Adverse Soils Conditions

Address(&lot): Following the civic Address Only- as note on Gemtec Memo 64153.80, 1500 Thomas Argue, D07-16-18-0007,
Subdivision, Phase, Builder: Soho West, West Capital Carp Airport Phase 2A
Geotechnical Memo (s) & Report (s): Gemtec # 64153.80, July 22, 2019, Grading Plan Review #64153.80, February 19,2021 a
Notes: Above ground pools to be assessed by geotechnical personnel.

February 19, 2021

**Re: Grading Plan Review
West Capital Airpark – Phase 2A Residential Development
Diamondview Road at March Road
Ottawa, Ontario**

FIGURE 1

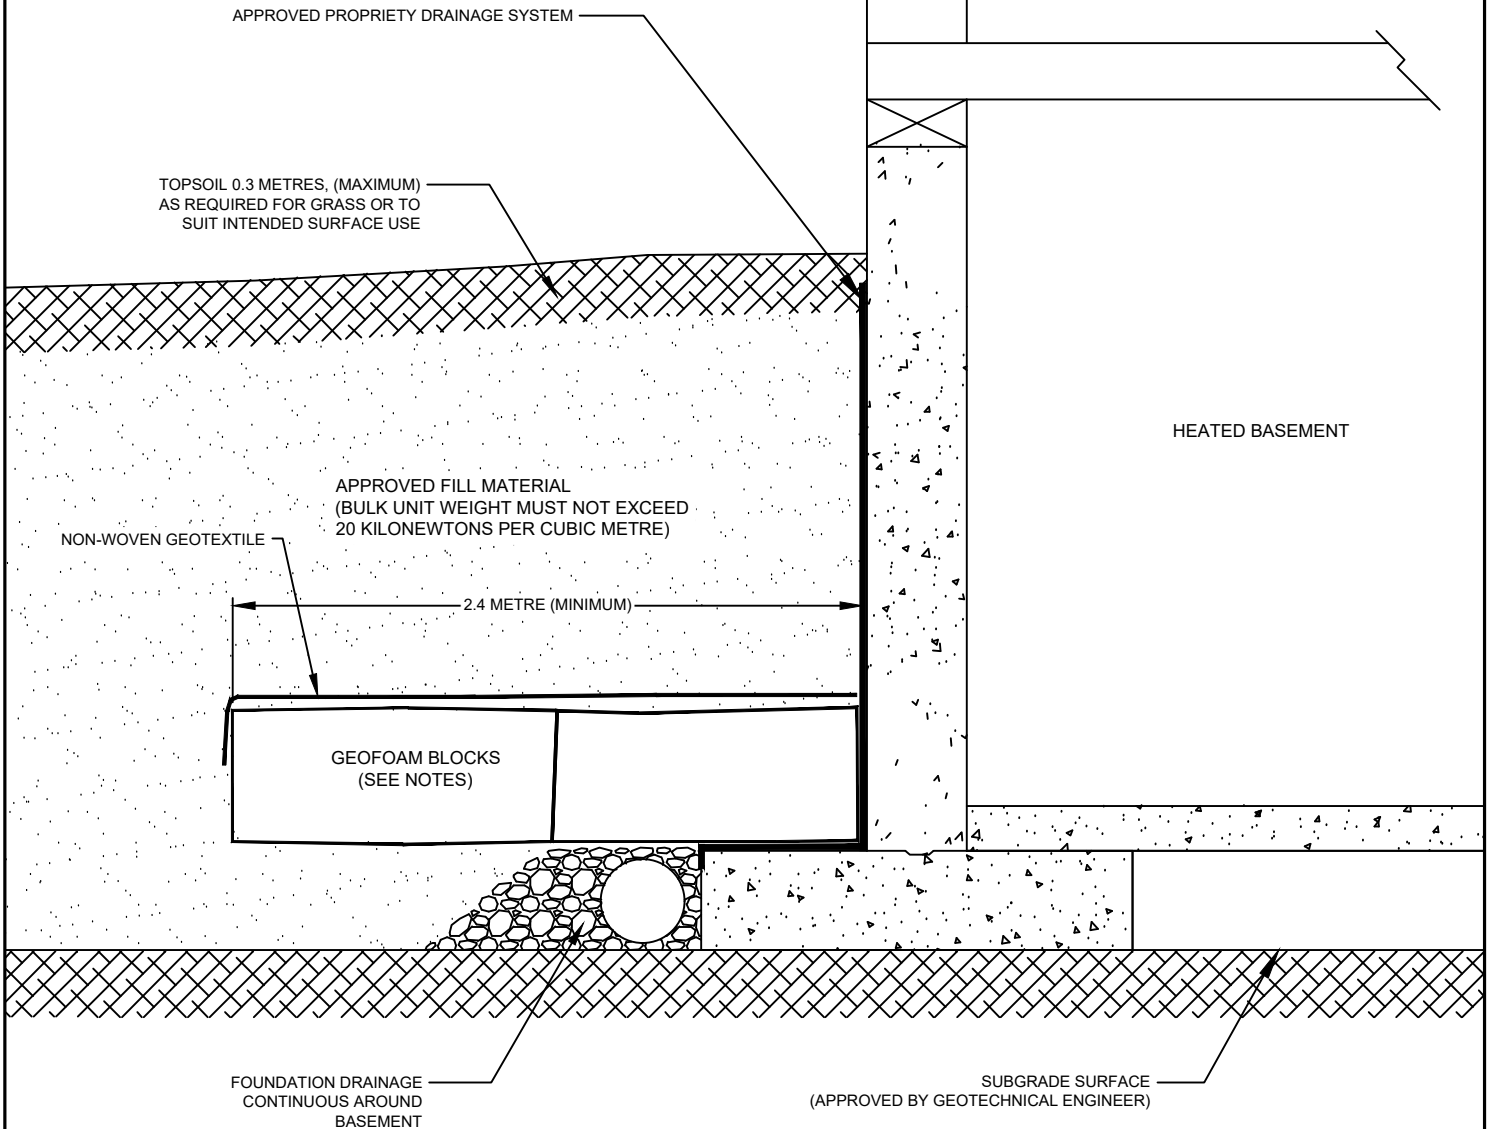
The EPS should extend at least 2.4 metres beyond the entire perimeter of the foundations and within the garages and porches, as shown in Figures 1 and 2. The thickness of the EPS should be equal to the thickness of the grade raise exceedance in Table 2, above.

Where two adjacent houses are not planned to be constructed at the same time, and where the spacing between houses is 2.4 metres or less, the EPS should be placed within 1.2 metres of the house to be constructed. The remaining 1.2 metres of EPS should be placed at the time the adjacent house is constructed. Additional information regarding the use of EPS blocks could be provided as the design progresses.

Figure 2 – Light Weight Fill for Garages and Porches

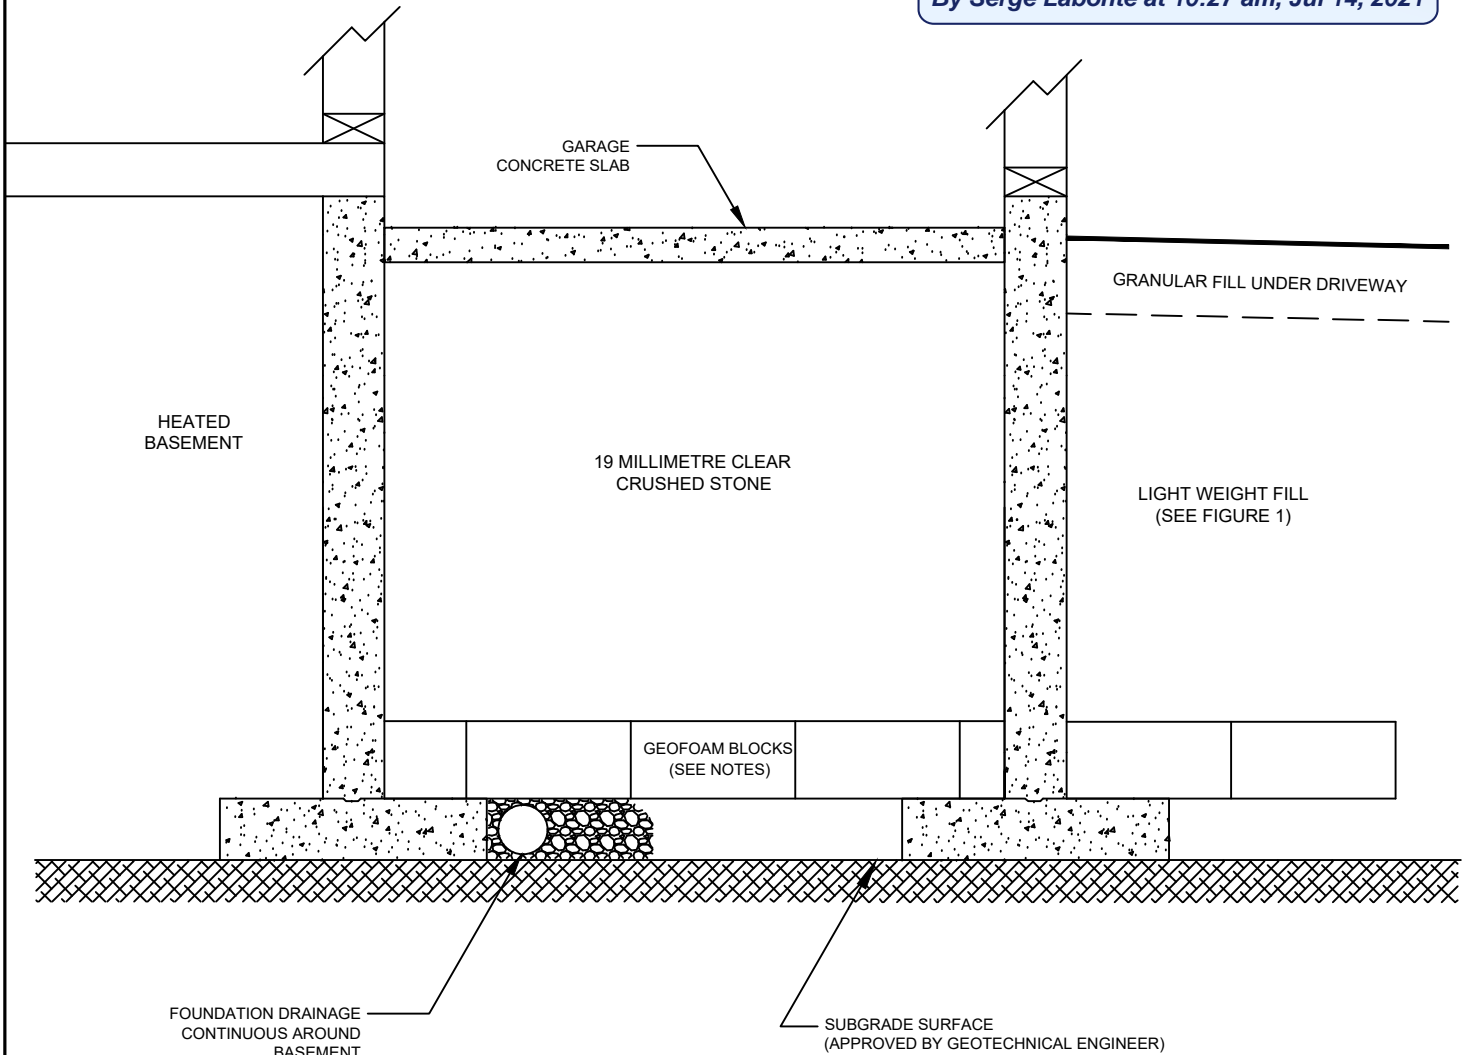
NOTE: Soil site class E has been revised to site class D. Please see below Paterson report.
